Date: November 6, 2023  
To: CLFLWD Board of Managers  
From: Mike Kinney, District Administrator  
Subject: Permit 23-015 Beltz Park Improvements- Phase I

<b>Project</b>	Beltz Park Improvements- Phase 1	<b>Date</b>	11-8-2023
<b>To</b>	Patrick Casey Paul Strong	<b>Contact Info</b>	Applicant Agent
<b>Cc</b>	Mike Sandager	<b>Contact Info</b>	CLFLWD
<b>From</b>	Greg D. Graske, P.E.	<b>Contact Info</b>	EOR
<b>Regarding</b>	Permit Application #23-015, City of Forest Lake

FOREST LAKE, MINNESOTA  
BELTZ PARK IMPROVEMENTS  
EROSION CONTROL PLAN & SWPPP

SHEET  
C2.01

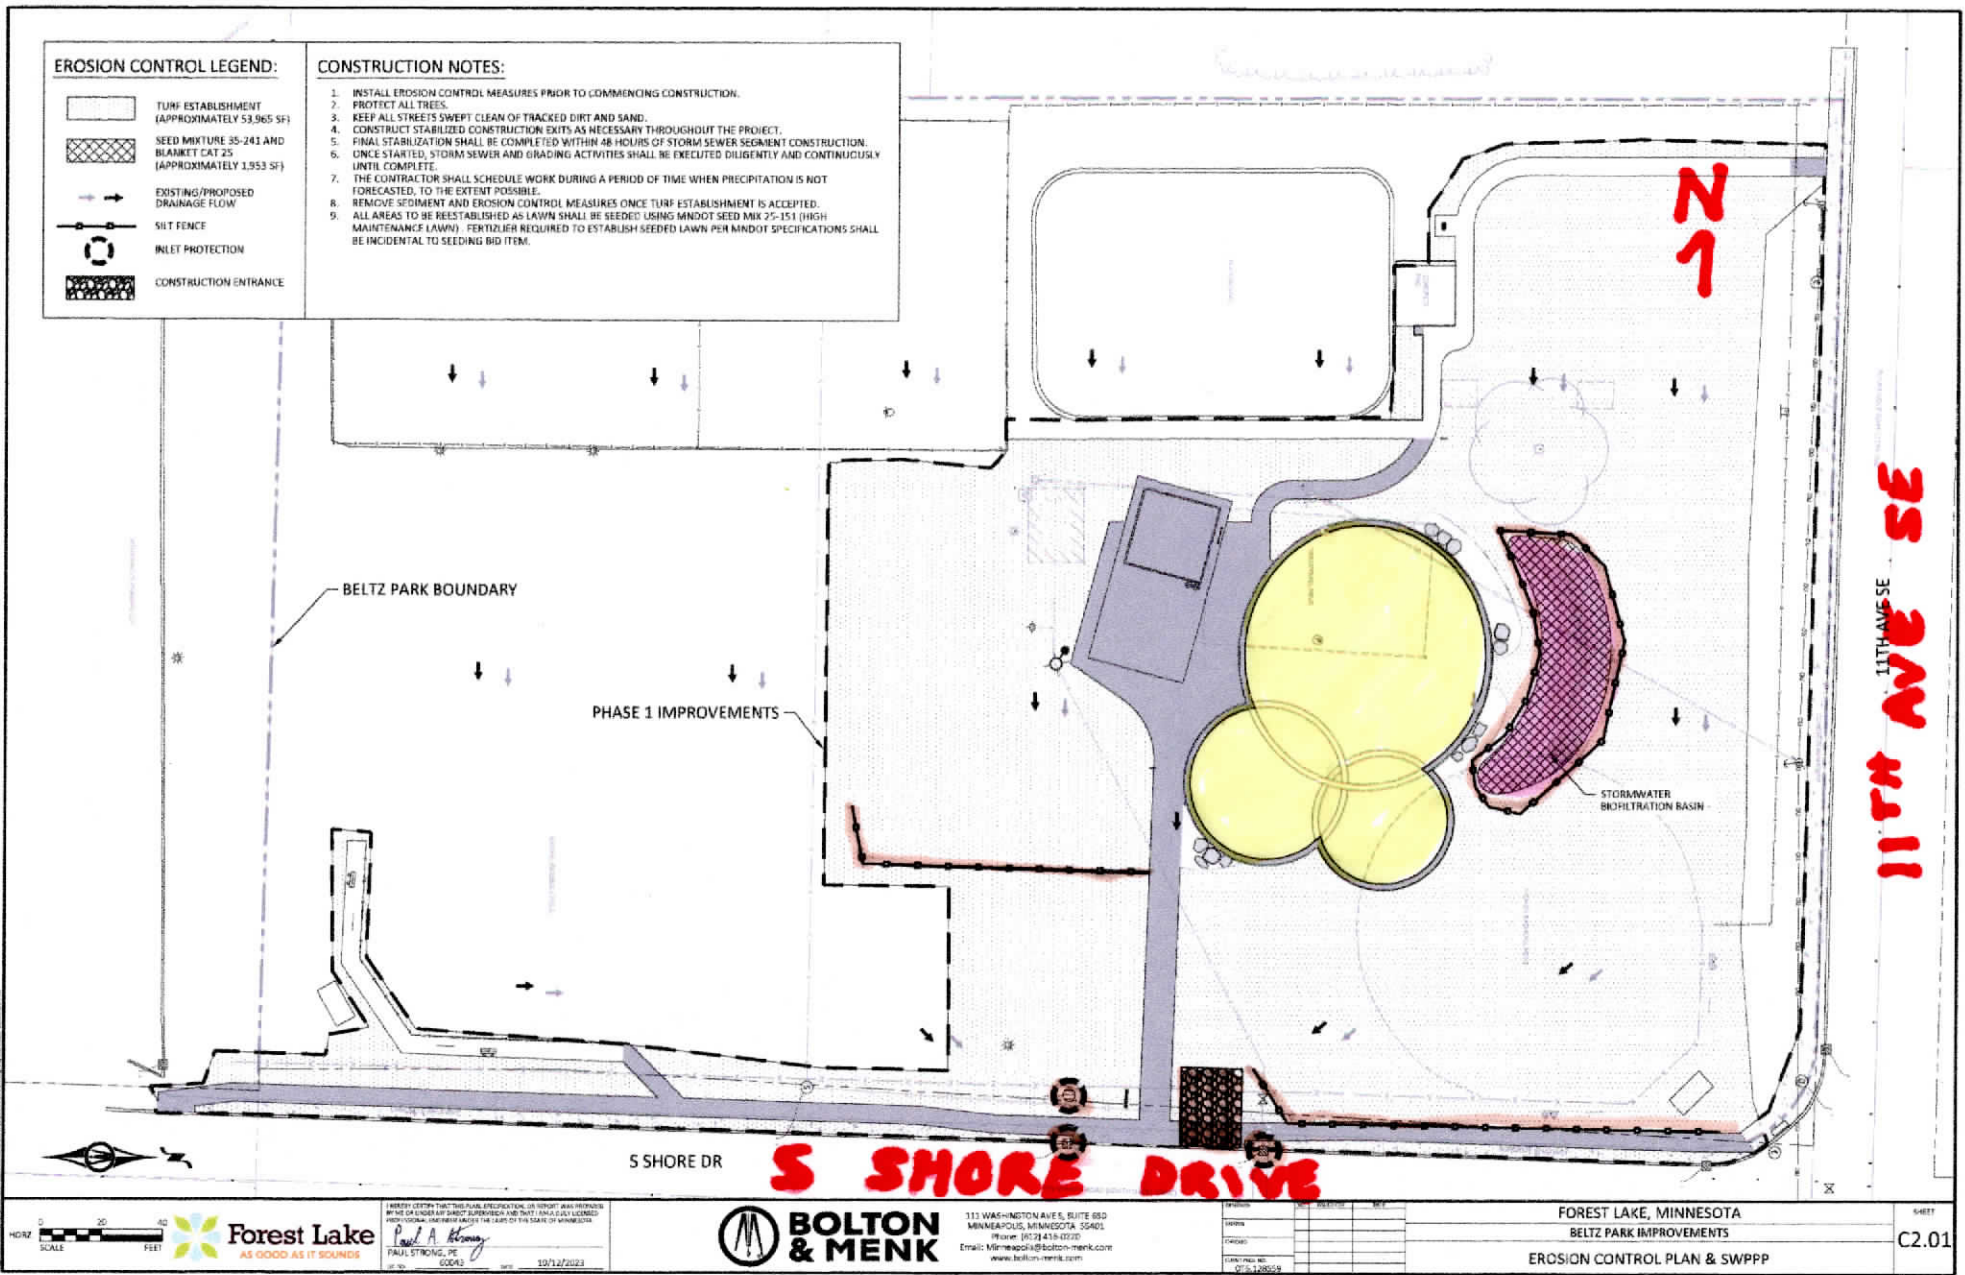
The proposed project includes silt fence, erosion control blankets, rock construction entrance, inlet protection, revegetation specifications and an implementation schedule. A detailed Storm Water Pollution Prevention Plan (SWPPP) has been submitted. The proposed plans meet District Erosion Control requirements. The District may require the installation of additional sediment control best management practices at a later time, if deemed necessary based on site conditions during construction.
